1137 Ogilvie Road and 1111 Cummings Avenue

**RE: UDRP Report
PC2024-0171
1137 Ogilvie Road and 1111 Cummings Avenue – Zoning By-law Amendment**

1137 Ogilvie Rd Architectural Design Report for Application for Rezoning 2024.07.18

1137 Ogilvie Rd GROUND FLOOR
 SCALE: TO FIT PAGE
 PLOT DATE: July 4, 2024

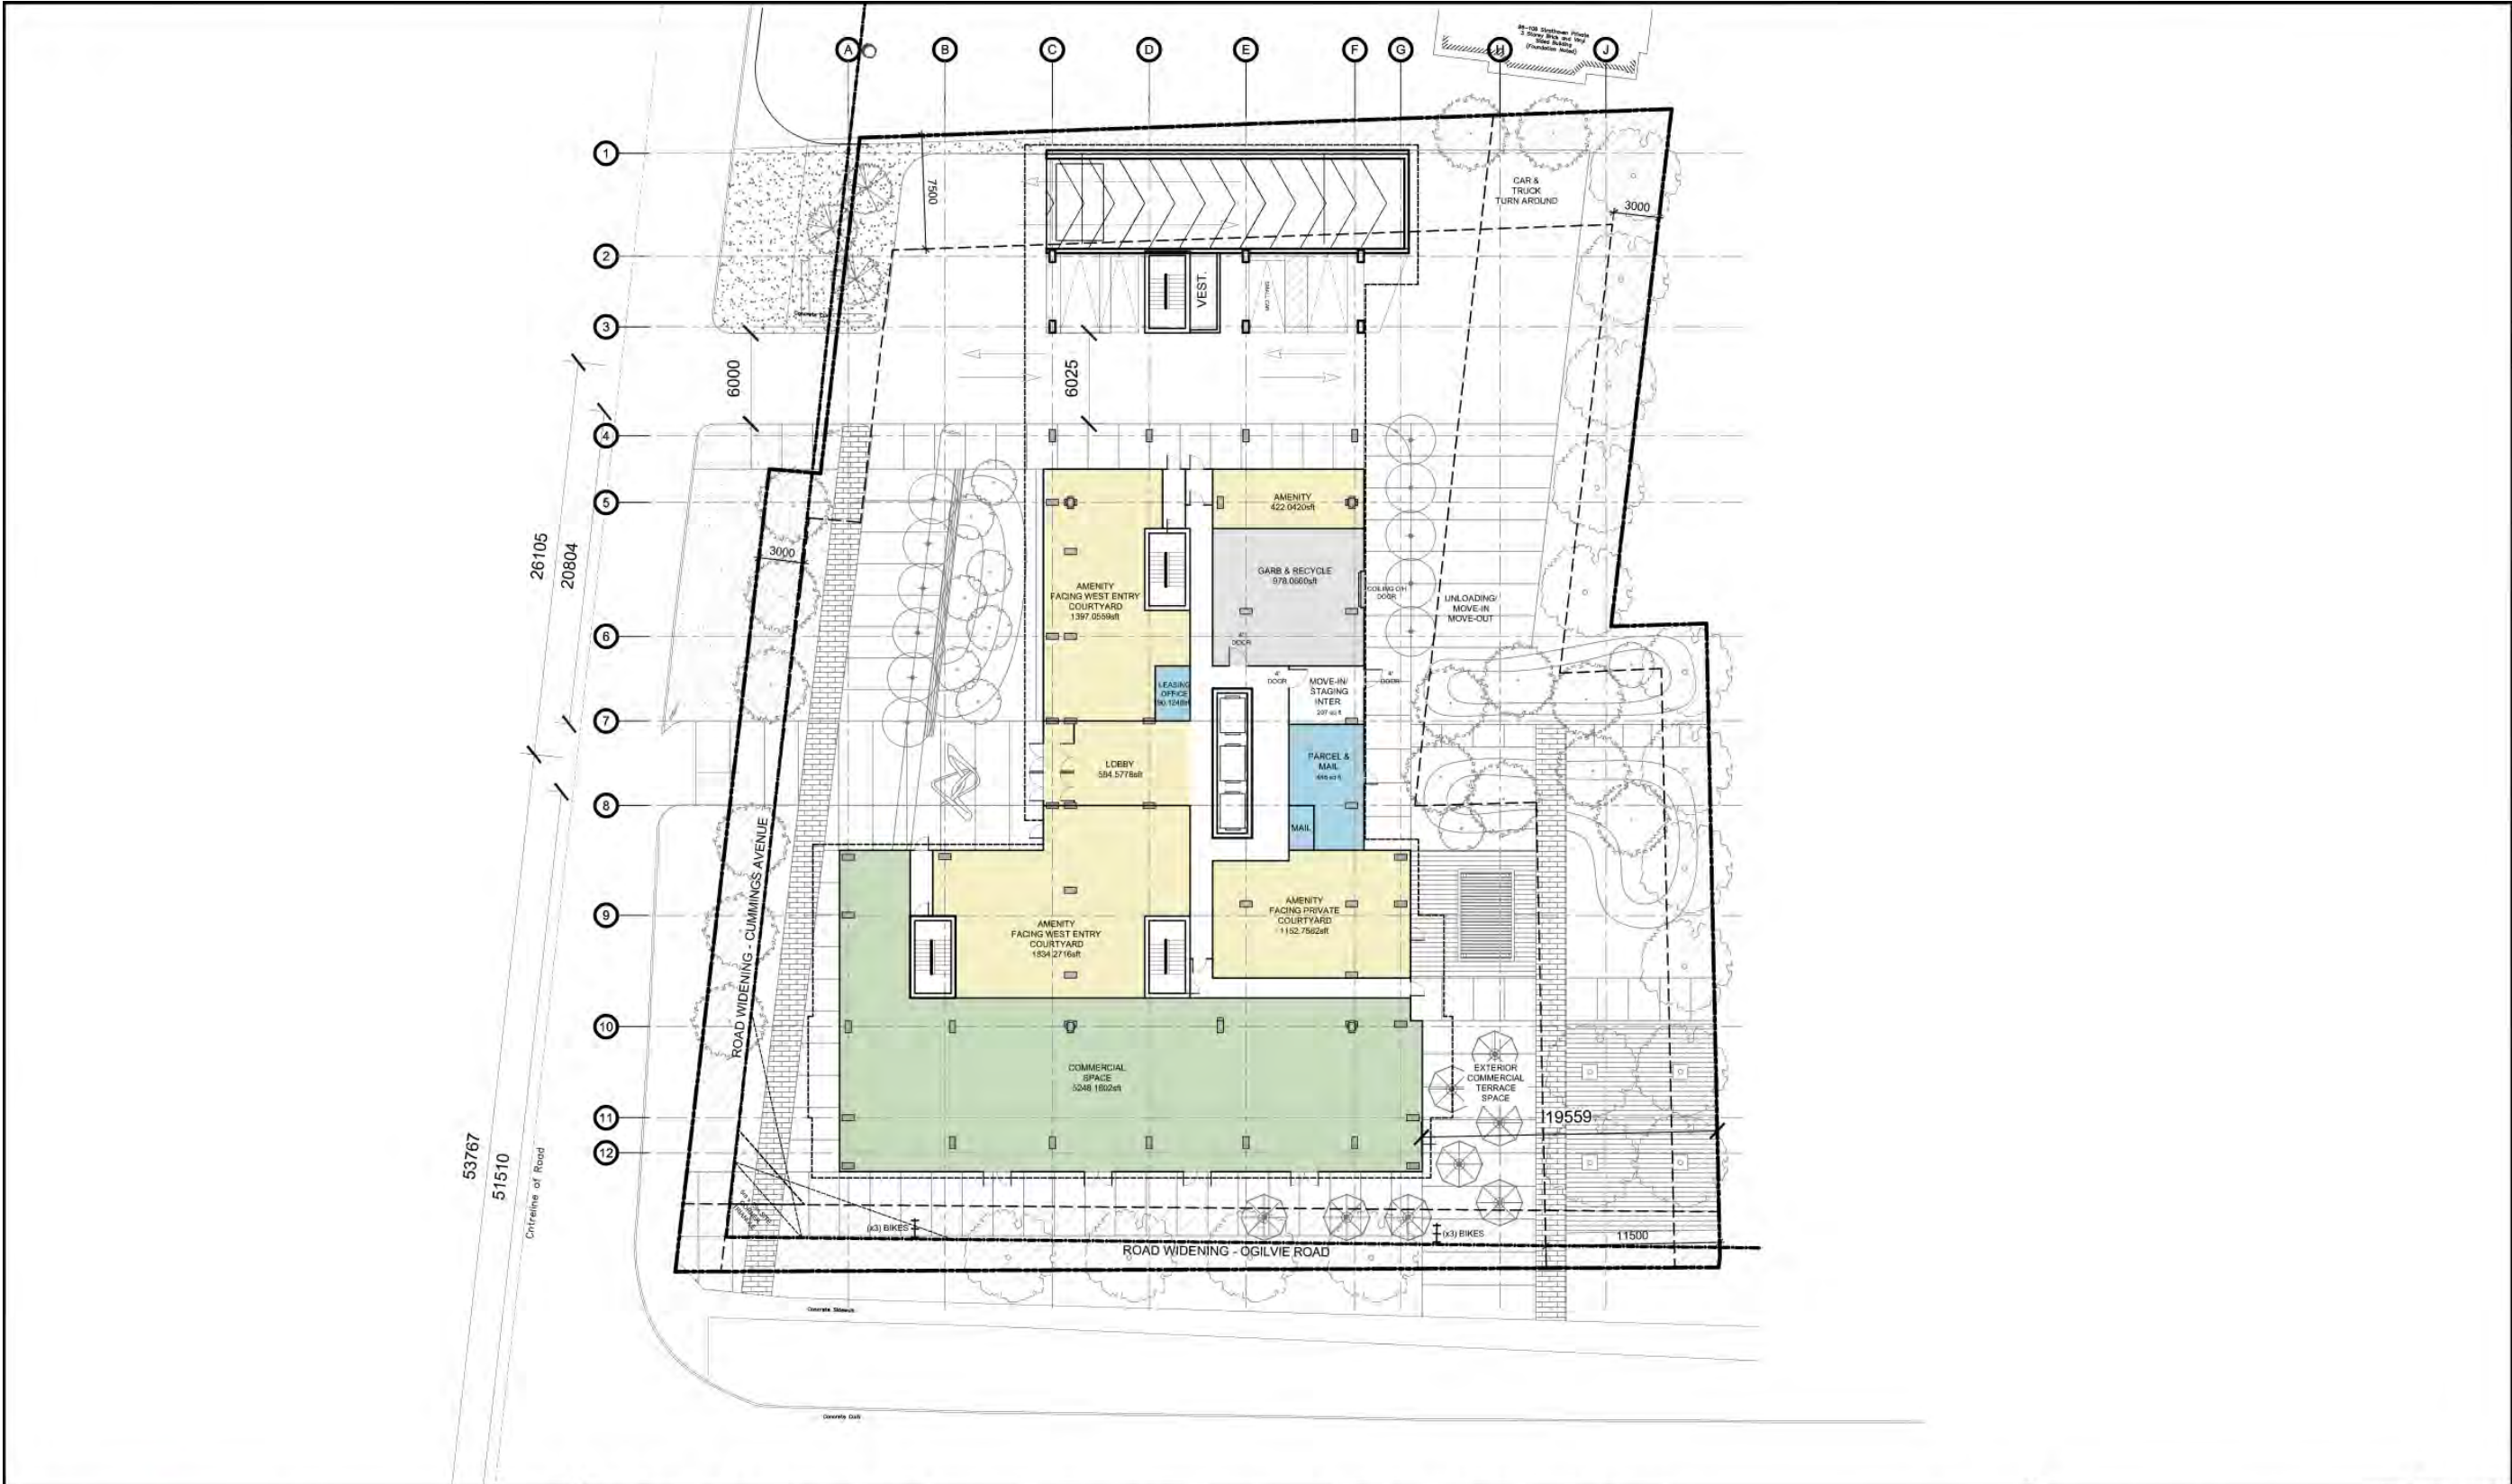
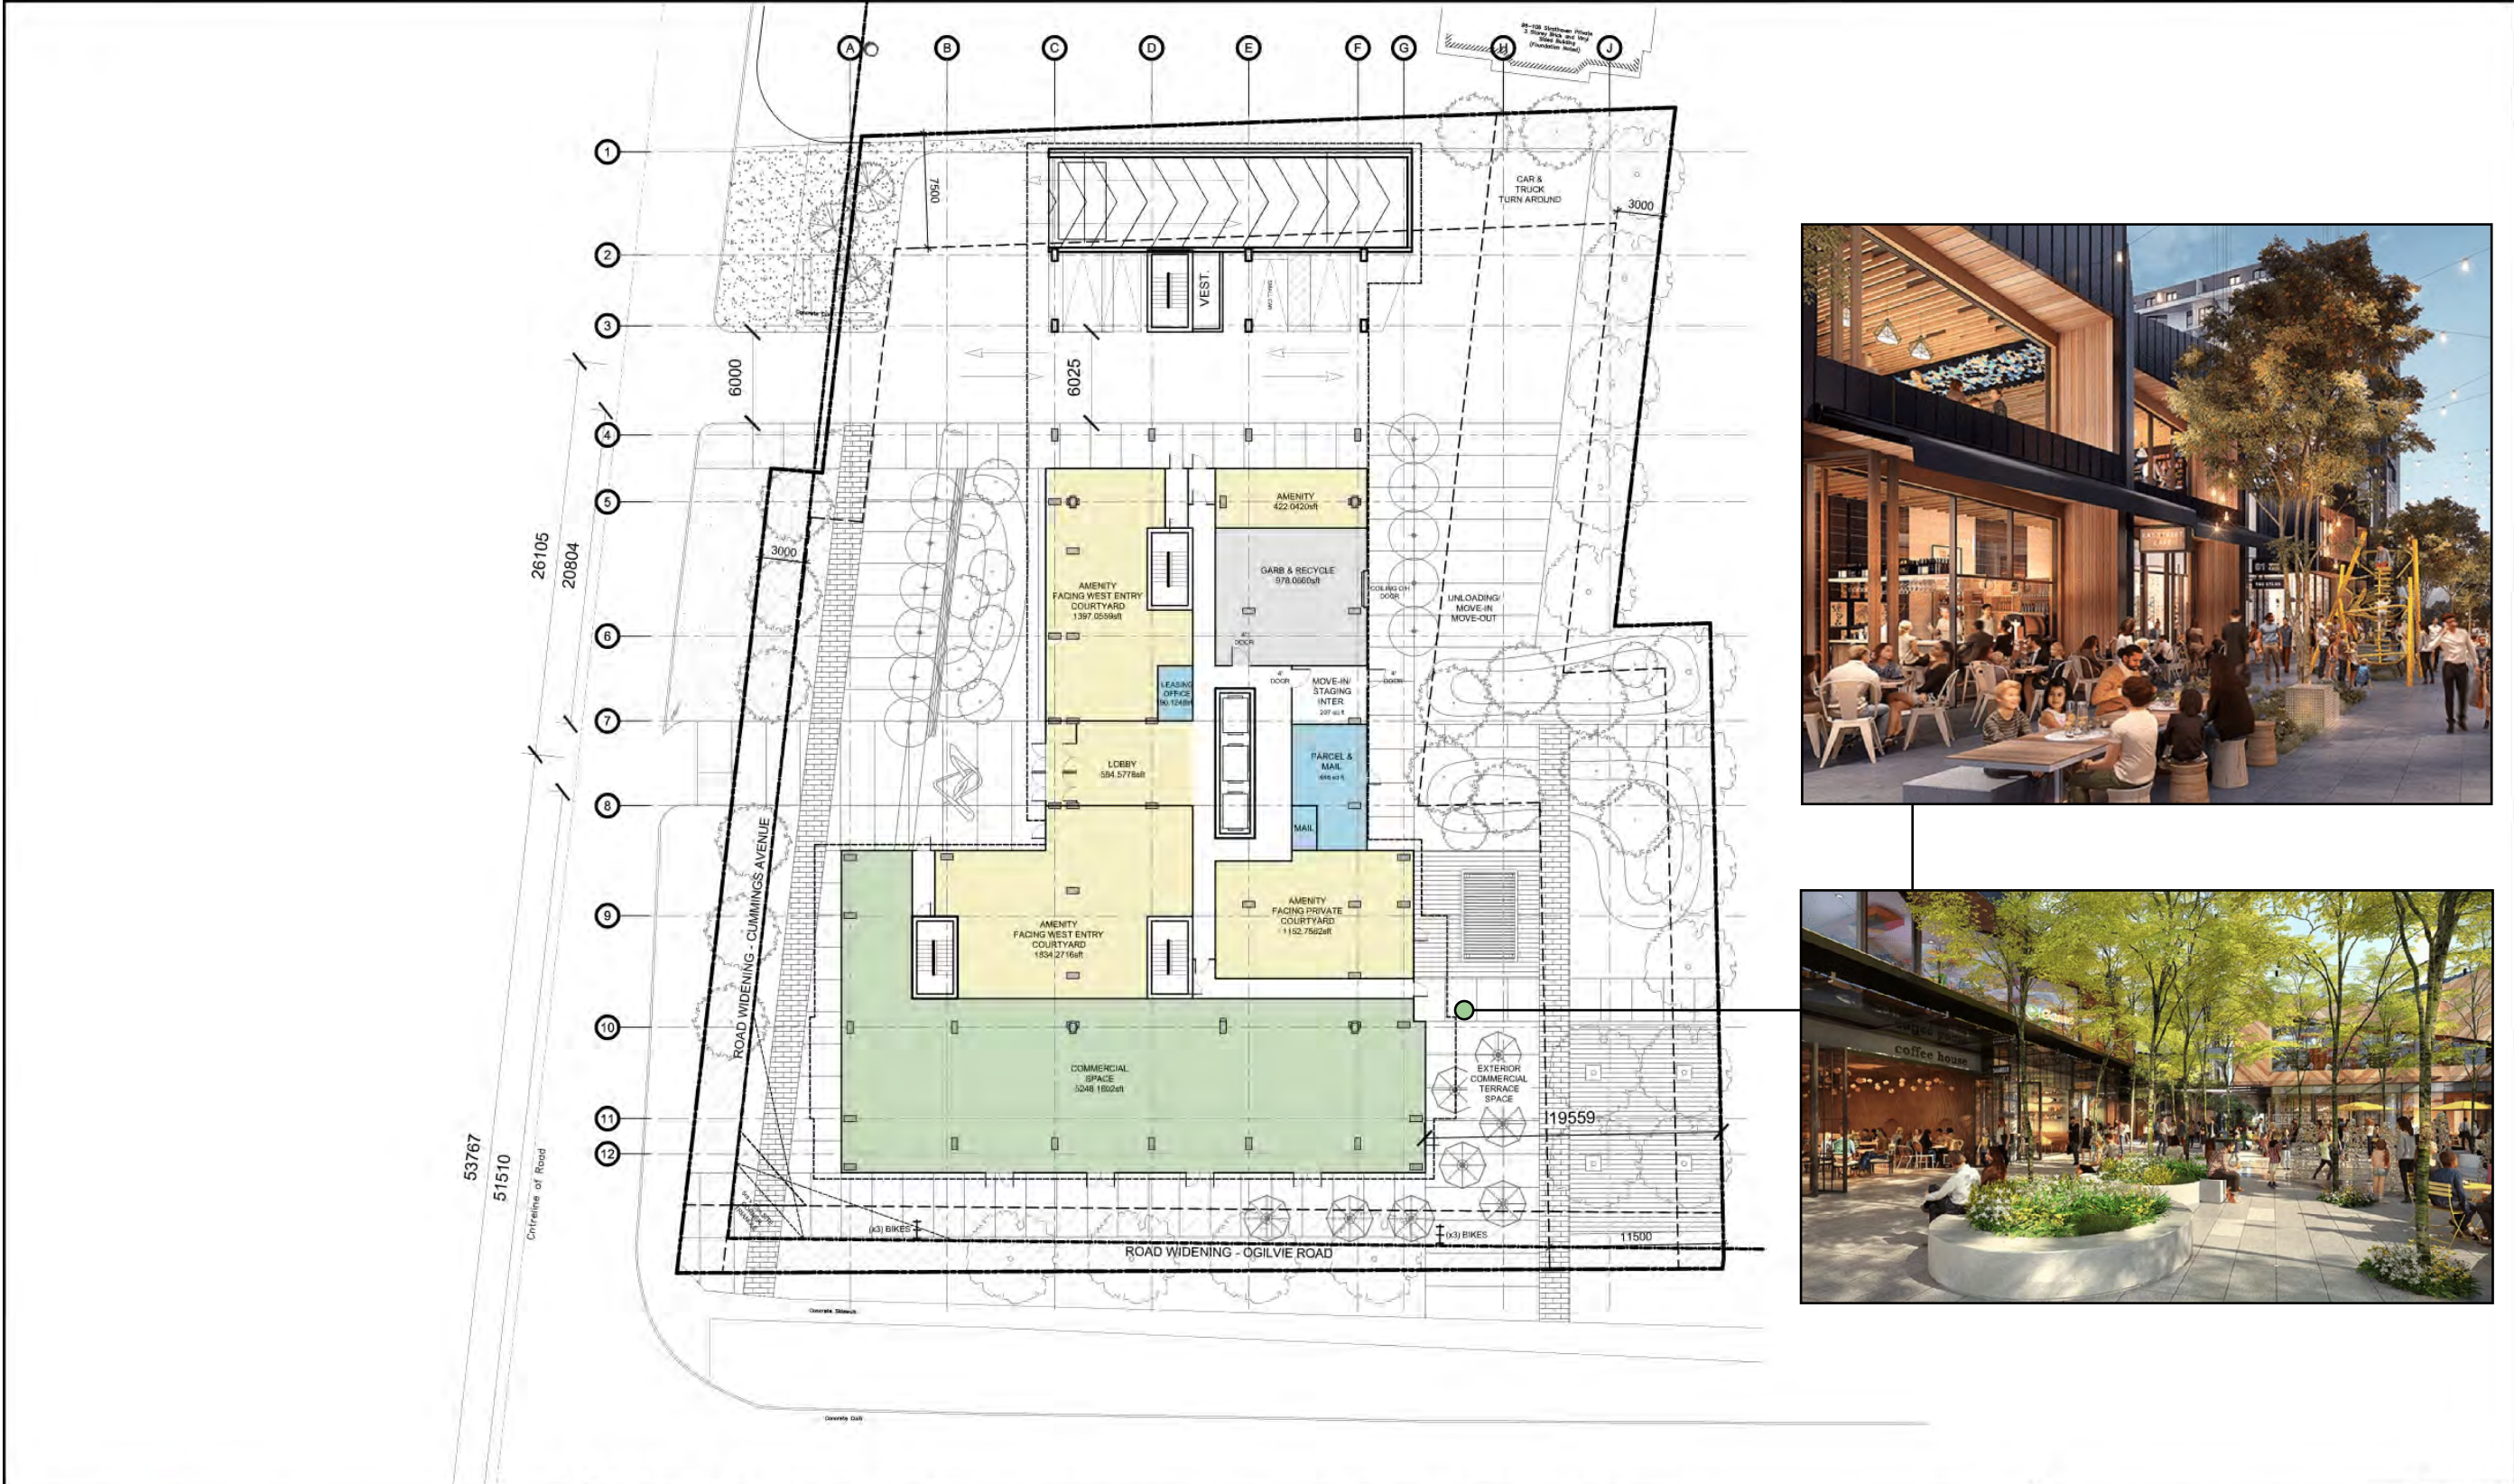
5	The Panel has concerns with the amount of space at-grade dedicated to hard surfaces and vehicular uses, and recommends consolidating the servicing, loading, parking ramp, and potentially the drop-off, within the building envelope.	As per the above response to point #4, there is limited setback area as you reach the northern extents of the subject site, and locating move-in/out and deliveries into the building form would cause extreme issues with traffic cueing and interruption, as the suggestion would require trucks and other vehicles to block off Cummings Avenue in an effort to back into service and loading bays. The landscape consultant team have also devised a strong site plan concept, where the use of strategic plantings, bollards, curbless hard-scapes and tactile surfaces strengthens the <u>primacy of the pedestrian spaces</u> .
6	The Panel recommends dedicating significantly more space at-grade to landscaping and outdoor amenities for both private and public community use, including greater pedestrian connections to the surrounding context.	The landscape consultant team has devised a strong site plan concept that prioritizes pedestrian spaces, connections between the interior and exterior amenities and has developed a strategy for plantings for deep soil zones beyond the footprint of the U/G parking garage and by using planters and earth forms (berms) for areas located above the UG parking structure.

2	The Panel recommends locating the loading, servicing, and parking ramp at the north end of the site/podium, and enclosing them within the building envelope/podium.	As per the above responses to points #4 & #5 in the Key Recommendations and point #1 (above), there is limited setback area as you reach the northern extents of the subject site, and locating move-in/out and deliveries into the building form would cause extreme issues with traffic cueing and interruption, as the suggestion would require trucks and other vehicles to block off Cummings Avenue in an effort to back into <u>service and loading bays</u> .
3	The Panel has concerns with the drop-off/delivery loop and recommends either removing it in favour of potential on-street lay-by or incorporating the drop-off within the podium envelope.	It is unlikely that of the City of Ottawa would be willing to permit a lay-by on Cummings Avenue considering the impending road widening along Cummings Avenue, and a potential future dedicated bike lane on this same street. It should also be noted that a layby has greater length than a one-way traffic cut and would be more disruptive to the future planned sidewalk along the western edge of <u>the subject site</u> .

4	The Panel has concerns with the two curb-cuts for the proposed drop-off loop creating reduced pedestrian safety and comfort along Cummings Avenue.	The drop-off and pick-up curb cut is a one-way traffic entry, and can only be accessed by traffic moving northward on Cummings Avenue. This greatly reduces the width of the curb cut and therefore offers minimal disruption to the sidewalk along the western property edge. The landscape consultant team has also developed a strong design concept for this area that takes advantage of tactile surfaces, decorative pavers, bollards and curbless surfaces to enforce traffic calming measures. The drop-off and pick-up area is also strategically located on the site to be in close proximity with the main lobby and elevator core on the ground floor, <u>which reinforces accessibility design standards</u> .
5	The Panel has concerns with the viability of the exterior amenity (courtyard) space, especially given the drop-off/delivery loop, and recommends eliminating the drop-off loop to provide a greater exterior amenity and entrance moment directly along Cummings Avenue.	The originally presented site design concept has been developed further and enhanced by the Landscape Consultant team, as the drop-off and loading areas have been given further design consideration through the careful treatment of site surfaces. That concept dramatically reduces the amount of asphalt on the site and treats the western entry court and drop-off area with a pedestrian first approach, implementing a number of traffic calming measures.

Comment	Response
6	The Panel advises removing the surface parking spaces, perhaps accommodating them in the below grade parking area.	With the exponential increase in the volume of parcel and food deliveries in multi-unit high-rise projects, we see this temporary parking area as a positive means of avoiding clogging up drop-off and pick-up areas, as well as those areas dedicated to loading and unloading and move-in/ move-out functions.
7	The Panel suggests more bicycle spaces are required on-site, preferably at grade. Consider further developing the cycling facilities/amenities.	Noted. We are currently reviewing options with the ownership group.
8	The Panel has concerns with the amount of area on the site that is dedicated to vehicular uses. Especially in contrast to the minimal space on site that is planned for landscaping/greenery. Consider enhancing the site design/layout with greater landscaping/greenery and minimalizing/internalizing the vehicular uses as much as possible.	As mentioned in a number of responses, The landscape consultant team has devised a strong site plan concept that prioritizes pedestrian spaces, connections between the interior and exterior amenities and has a strategy for plantings for deep soil zones beyond the footprint of the U/G parking garage and by using planters and earth forms (berms) for areas located above the UG parking structure.
